### TOWN OF MOUNTAIN VILLAGE REGULAR DESIGN REVIEW BOARD MEETING AGENDA THURSDAY JANUARY 4, 2023, 10:00 AM MOUNTAIN VILLAGE TOWN HALL 455 MOUNTAIN VILLAGE BLVD, MOUNTAIN VILLAGE, COLORADO TO BE HELD HYBRID THROUGH ZOOM:

AGENDA ITEM 3 PLANNING & DEVELOPMENT SERVICE PLANNING DIVISON 455 Mountain Village Blvd. Mountain Village, CO 81435 (970) 728-1392

**FROM:** Claire Perez, Planner II

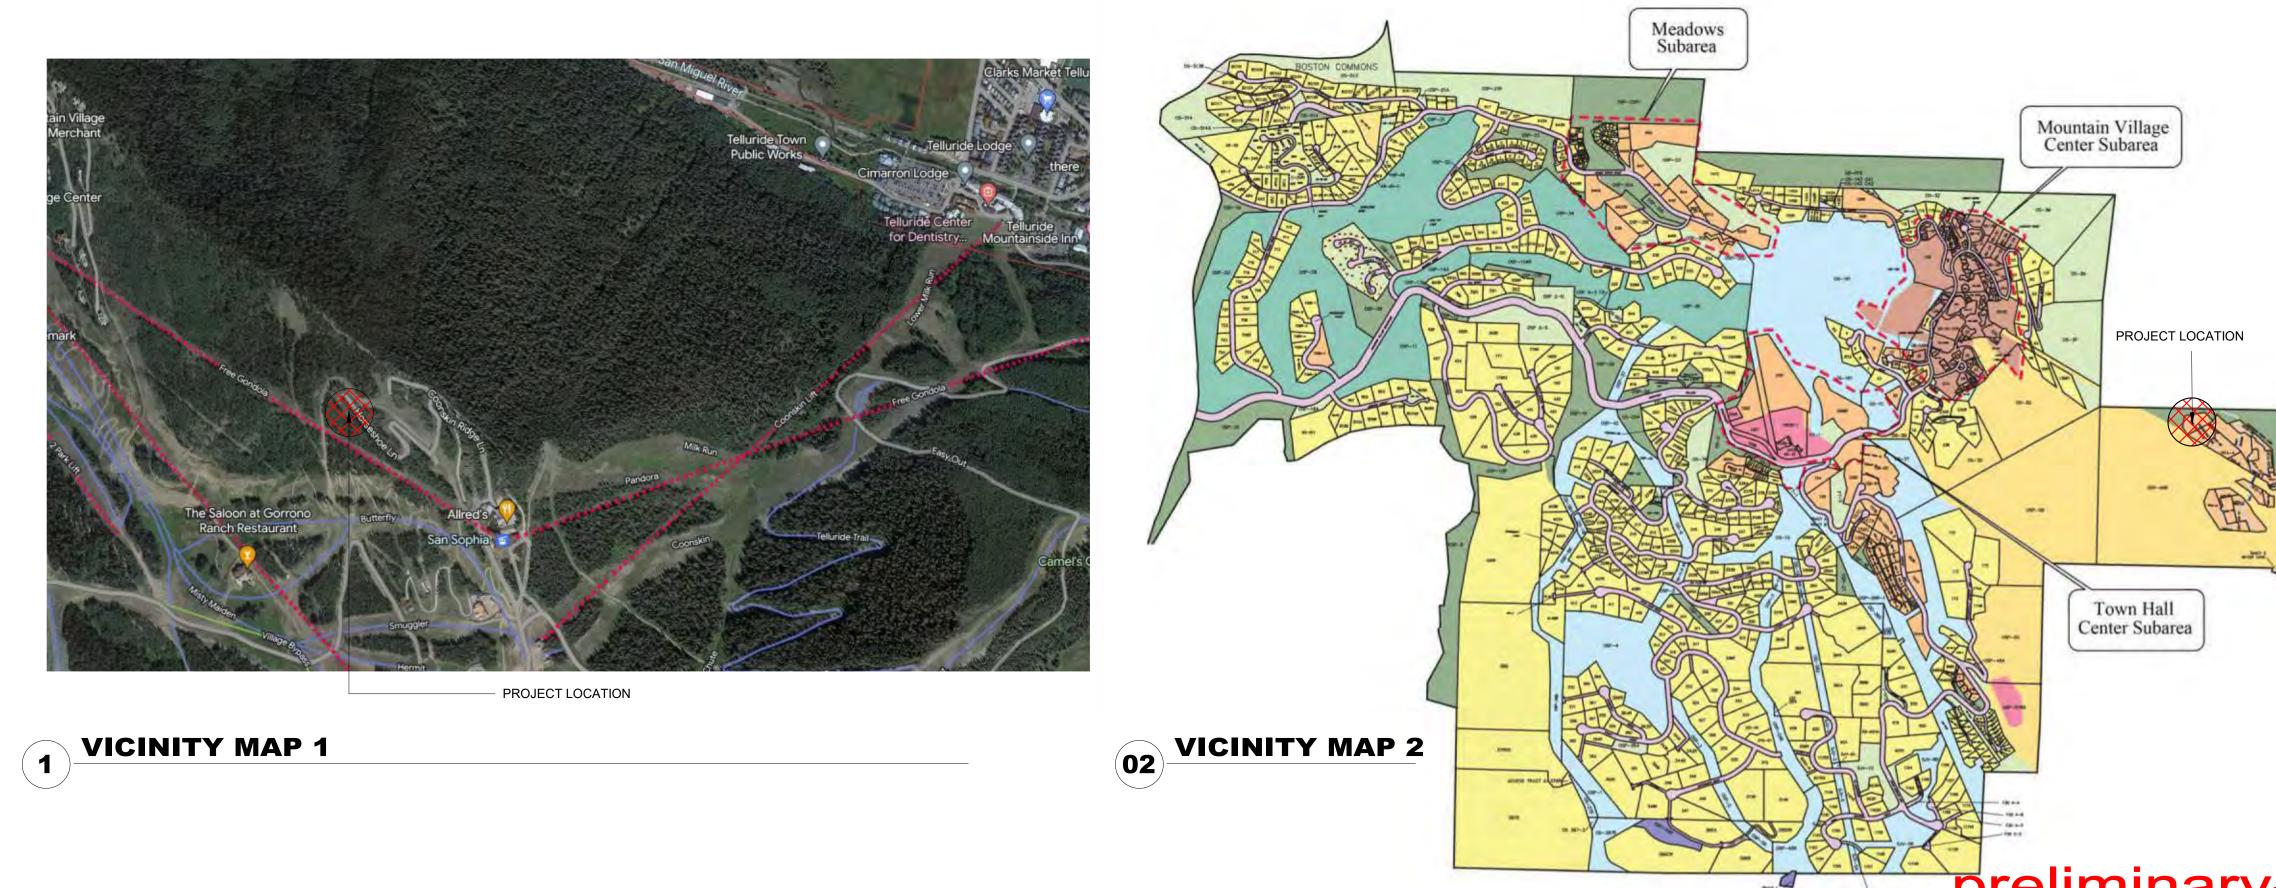
The site design has deleted an outdoor firepit area outside of the building envelope AND deleted the hot tub outside of the envelope.

Additionally, the deck at the lower level outside of the envelope has been removed. A small patio remains with a retaining wall on the northwest side to provide ski in and ski out access the ski room/home. The retaining wall at this area has been stepped/broken into two sections to reduce the perceived scale of it.

The building envelope has been better described to include all roof overhangs.

The lighting plans have been revise to reduce the number of fixtures, drop lumens, lower mounting heights and recess where possible. Additionally, the landscape bollard spec has been revised.
